101 MEADOWLILY ROAD SOUTH

Project Update Presentation

March 29, 2021 – Planning and Environment Committee Meeting

PROJECT OVERVIEW

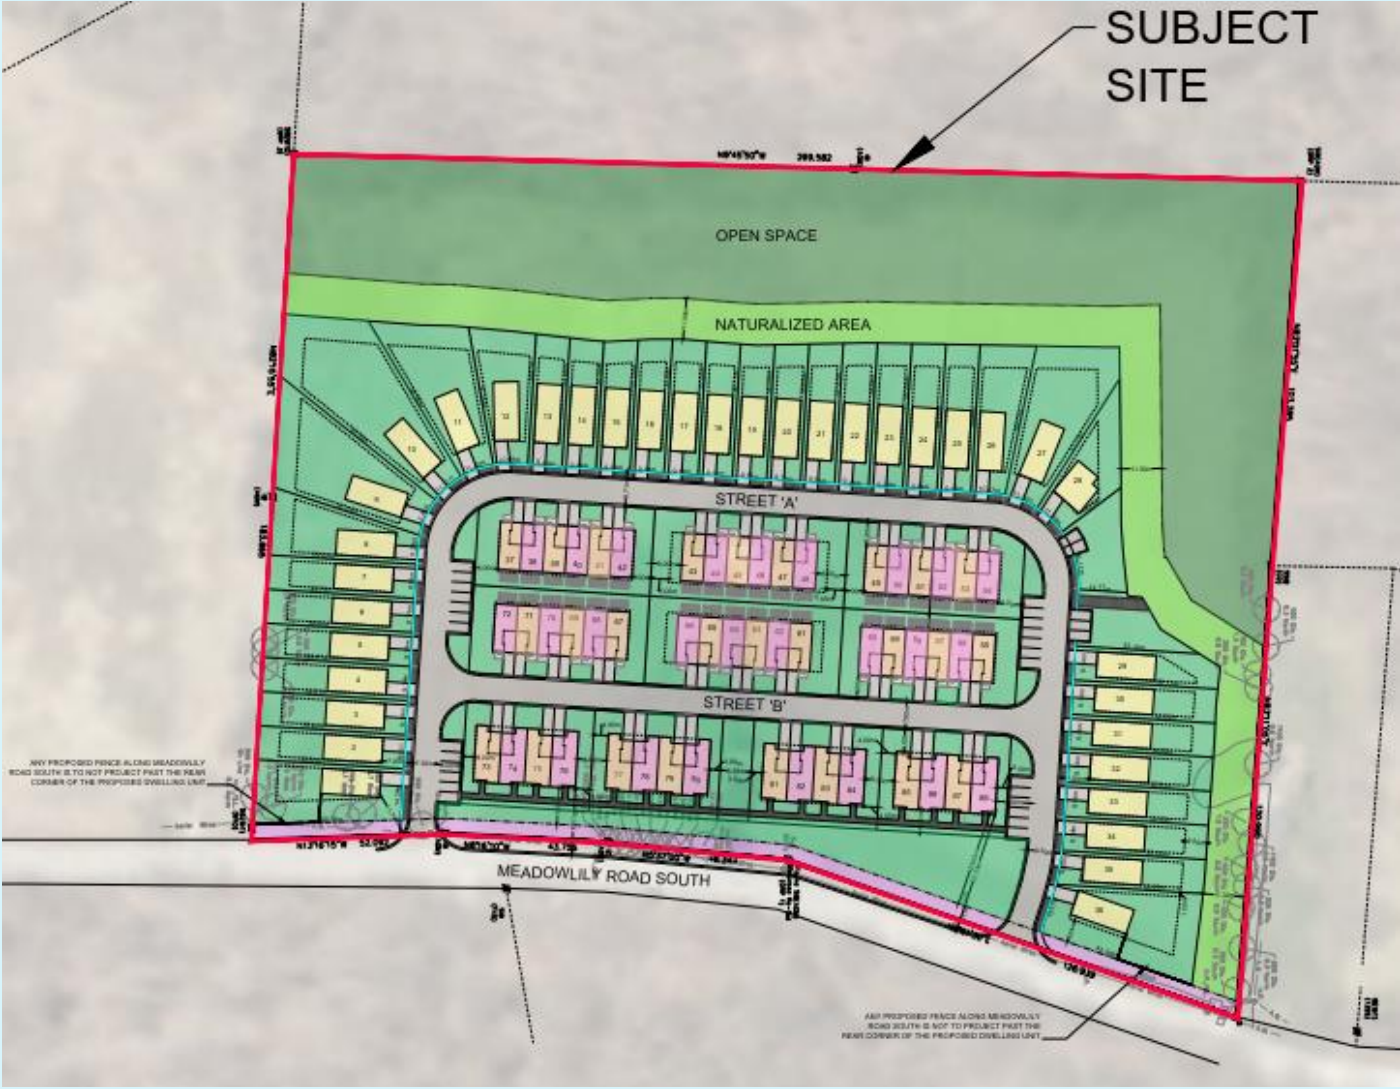
- 36 Single Detached Dwelling Units (One less than previously proposed), 52 Townhome Dwelling Units for a total of 88 units.
- All units have been designed to a maximum of 2.5 storeys in height, as required by the by-law (reduction from 3 storeys in original proposal).

- Direct access to Meadowlily Road South for individual townhome units have been removed and internal access provided, allowing for a larger setback from the ESA and additional landscaping/tree planting to intensify the visual buffer between the road and the development.

- Visitor parking within the site has been increased from the required ten (10) to thirty-one (31) spaces, well over the number of parking spaces required under the by-law.
